SAS Asynchronous Event Reporting

**02-175r0
Ralph O. Weber**

SAS AEN Picture from 02-158r0

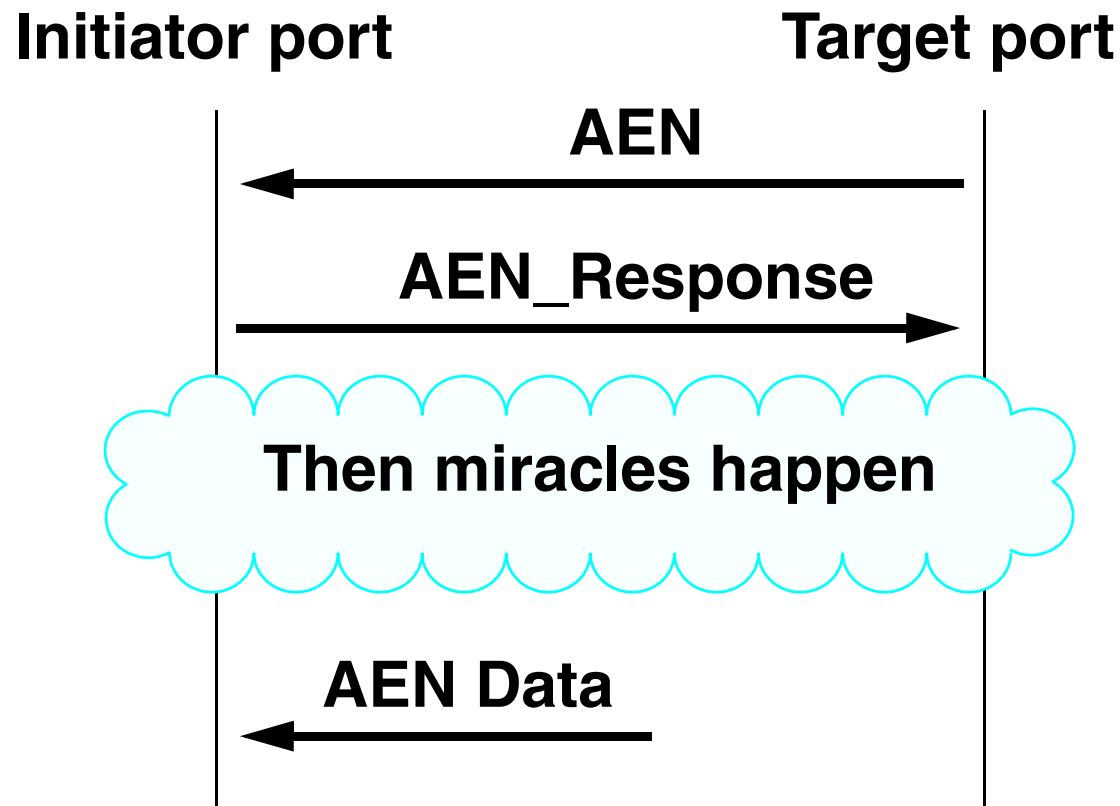
Miracle 1

- **The SAS protocol engine sends REPORT LUNS and REQUEST SENSE commands to obtain the AER sense data**

~~Miracle~~ Abomination 1

- The SAS protocol engine sends REPORT LUNS and REQUEST SENSE commands to obtain the AER sense data
- There is history for this ...
very very bad history
- This absolutely breaks the layering between protocols and application clients

Miracle 2

- **REPORT LUNS and REQUEST SENSE stay in synchronization regarding which logical units have AER data to be retrieved**
- **This is a very big assumption**
- **It is far better to have only one command that both**
 - **Decides if AER data is there, &**
 - **Retrieves the AER data**

Miracle 1 — Option A

- **If the desire is to transfer the AER data completely within the SAS protocol...**
- **Then, define SAS protocol commands to do the job**

Miracle 1 — Option B

- **If the desire is to transfer the AER data using SCSI commands...**
- **Then, define a Transport Attention that notifies the application client that AER data is available**

Miracle 2 — Proposed Solution

- **Add a descriptor format sense data descriptor to contain the LUN to which the sense data applies**
- **Add a well known LUN to which AER retrieval REQUEST SENSE commands are sent**
- **Only REQUEST SENSE needed to retrieve AER data**
